# intel® Technical Advisory

TA-0778-1

## Improving ambient noise levels when integrating the Intel® Server Board SE7320EP2 with the Intel® Server Chassis SC5275-E

**Figure 1. Front Panel Board Access**

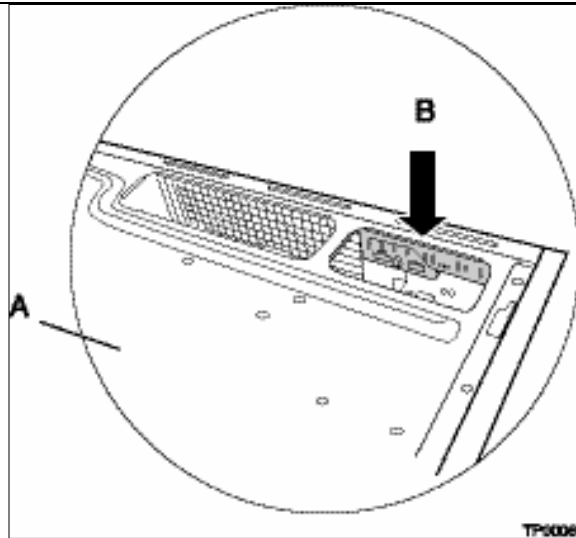
1. Remove the left access cover.
2. Remove the bezel.
3. Remove the two screws at the rear of the chassis that hold the right access cover in place.
4. Remove the right access cover. A rectangular opening at the right side of the chassis provides access to the front panel board.

**Figure 2. Removing the Front Panel Board**

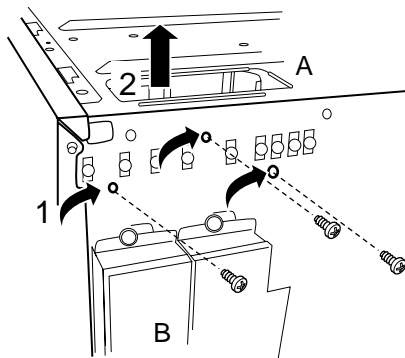
5. Disconnect the front panel cable from the front panel board.
6. Remove and save the three screws holding the front panel board to the chassis. See number 1 in the figure below
7. Remove the front panel board through the access hole. See number 2 in the figure below

**Figure 3. Attaching the Front Panel Cable**

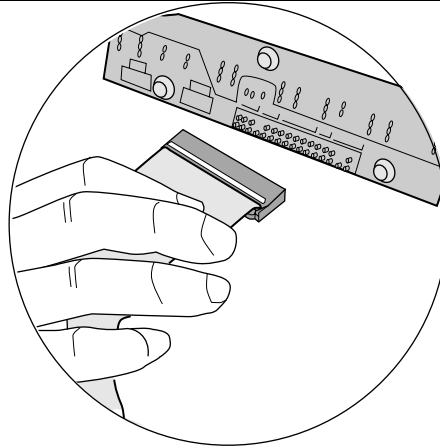
8. Slide the end of front panel board cable through the front panel opening and attach it to the new front panel board. Attach the cable before installing the new front panel board into the chassis to ensure the cable pins line up correctly.

**Figure 4. Inserting the Front Panel Board**

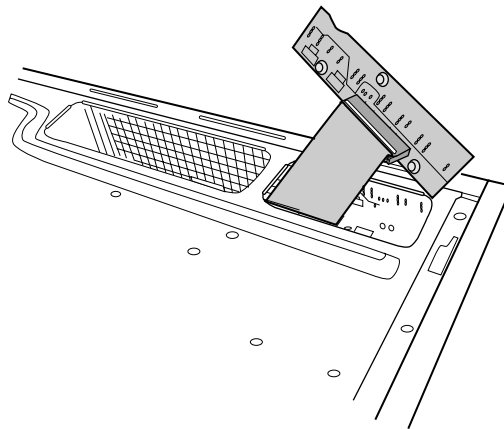
9. Place the new front panel board in the chassis.
10. Insert and tighten the three screws removed earlier.
